CHANGE ORDER REQUEST

Project Name: West Hardin Middle School

Re: Wehr Request No. **CO 3**

DESCRIPTION OF CHANGE: **PR 3 – Unsuitable Soils at Pond**

Reference Image from PR-003 and Solid Ground's Report

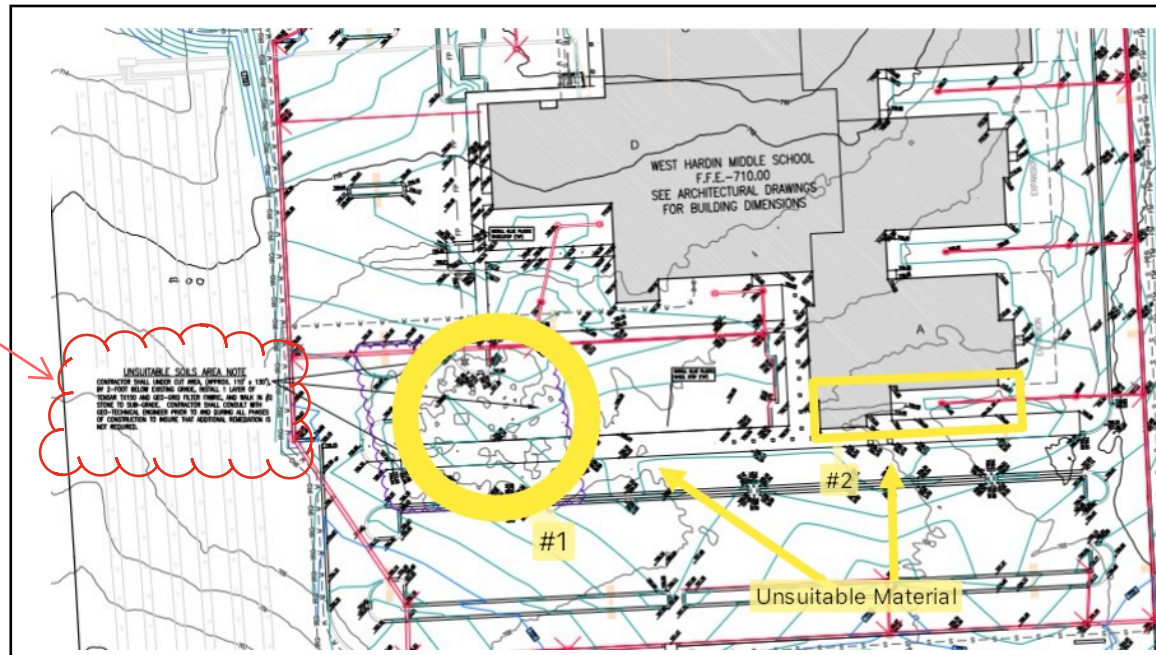
Area 1 - 110'x130'x8'

Area 2 - 21'x96'x2'

****A \$64,400.00 credit will apply to for the original undercut allowance included in the base bid****

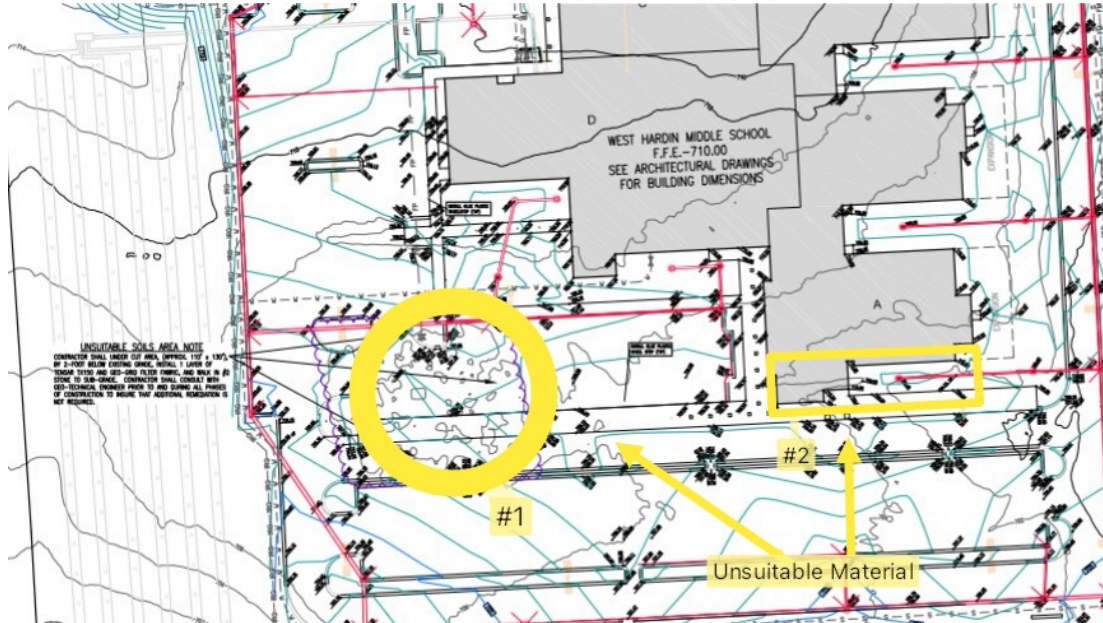
On site, Solid Ground Consulting Engineering, has identified that at the Pond Area, the proposed 2' undercut material to be inadequate for Tensar use. Added remediation needed to bridge over softer than expected material with high organics. Contractor to provide pricing for 2 options noted below.

Option #1

Recommend undercutting to elevation 698.0' where a firm red clay was encountered.

Place engineered fill in a 12-18" loose lift at the bottom of the undercut (target compaction of 92%)

Place engineered fill in 8-12" loose lifts up to 5 feet below subgrade elevation (target compaction of 95%)

Place engineered fill in maximum 8" loose lifts to subgrade elevation at 98%

Option #2

Undercut to elevation 703.0' place channel liner to #2 stone in 6-8" lifts and walk into subgrade until the subgrade accepts no additional stone.

Place a layer of TX-130 geogrid, capped with 8" of DGA.

Place engineered fill in maximum 8" loose lifts to subgrade elevation at 98% compaction.
